**Volvo Car USA LLC**
**Technical Journal**

Technical Journal Title <b>Creaking/ticking noise from Steering Wheel Module</b>		Ref. No. <b>TJ 36805.1.0</b>	
Issuer (Dept.) <b>Technical Service</b>		Issue Date <b>2/9/24</b>	Status Date <b>3/7/24</b>
Car Market <b>United States and Canada</b>	Partner <b>3 US 7510 Volvo Car USA</b>	Function Group <b>3644</b>	
Function Description <b>Housing for direction indicator switch</b>		Page <b>Page 1 of 6</b>

TJ Instruction VCC-528590-1

<b>Title</b>	Steering column	<b>Page</b>	1 ( 3 )
<b>Action</b>	Adjustment	<b>Operation number:</b>	98585-2

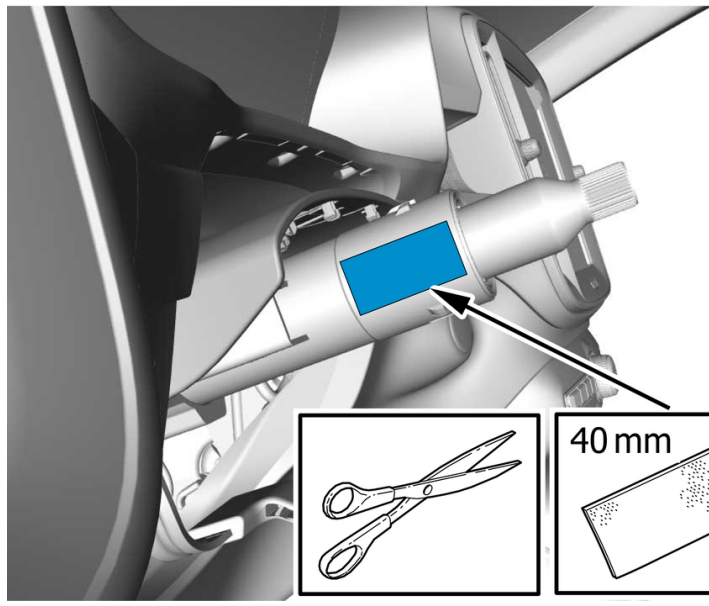
Remove steering wheel module (SWM) , refer to:

Use tape  
Adjust to the specified value.

**Use tape Part No:** 30643492 (50\*25\*0,6)(mm)
